Joint Meeting of Experts on the Regulations annexed to the  
European Agreement concerning the International Carriage  
of Dangerous Goods by Inland Waterways (ADN)  
(ADN Safety Committee)

## **Proposal for the implementation of the modified concept for explosion protection on board inland waterway vessels**

### **Transmitted by the Central Commission for the Navigation of the Rhine (CCNR)\* \*\***

# Classification of zones for tank vessels

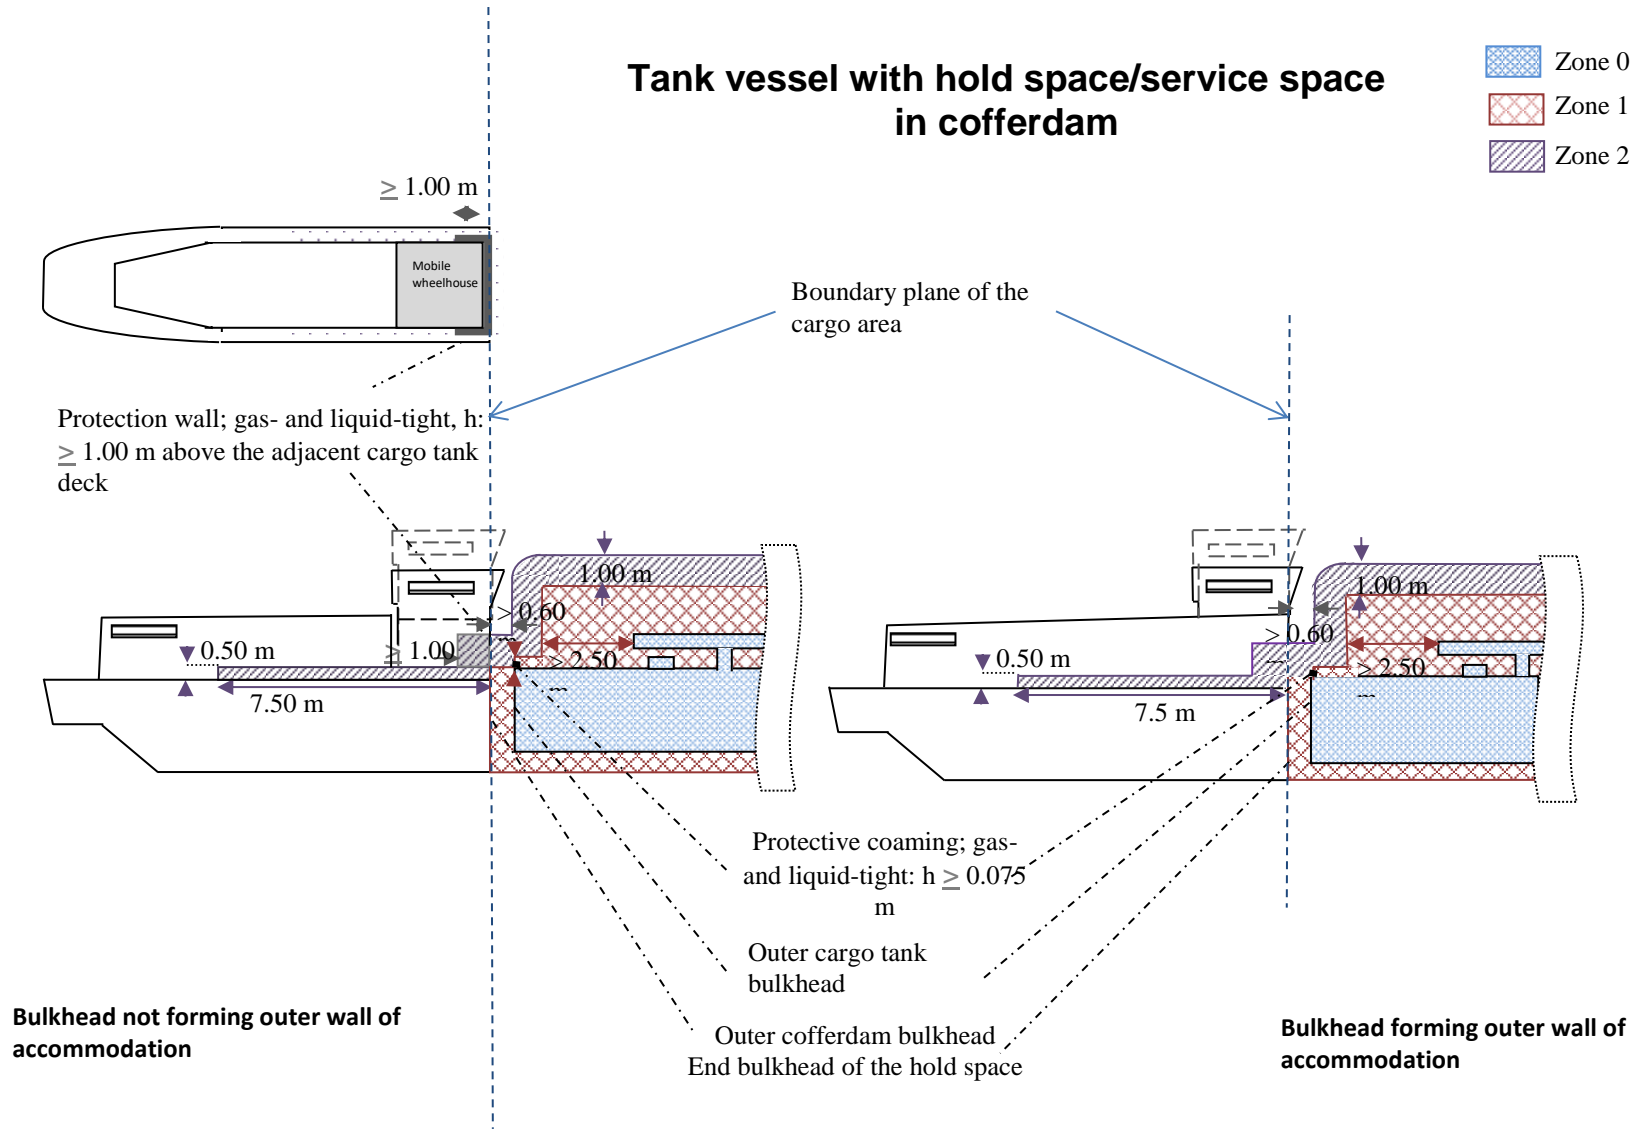
- All spaces located below deck in the cargo area not part of zone 0.
- Closed spaces on deck within the cargo area.
- The deck in the cargo area over the entire width of the vessel to the outer cofferdam bulkheads.
- Up to a distance of at least 1.60 m to the “boundary planes of the cargo area”, the height above the deck is 2.50 m, but at least 1.50 m above the highest piping carrying cargoes or cargo vapours.

If the ship is built with hold spaces or a cofferdam/ part of a cofferdam is arranged as a service space, the adjacent height (fore and aft) to the “boundary plane of the cargo area” is 1.00 m above deck (see diagram).

- On the deck in the cargo area, a zone extending 1.00 m upwards and joining zone 1 longitudinally.
- On the fore deck and the aft deck, an area 7.50 m in length across the entire width of the vessel and adjacent to the “boundary plane of the cargo area”. Between the lateral side of the vessel and the protection wall, the length and height of this area equals the dimensions of the lateral side of the protection wall. Elsewhere, the height in zone 2 is 0.50 m.
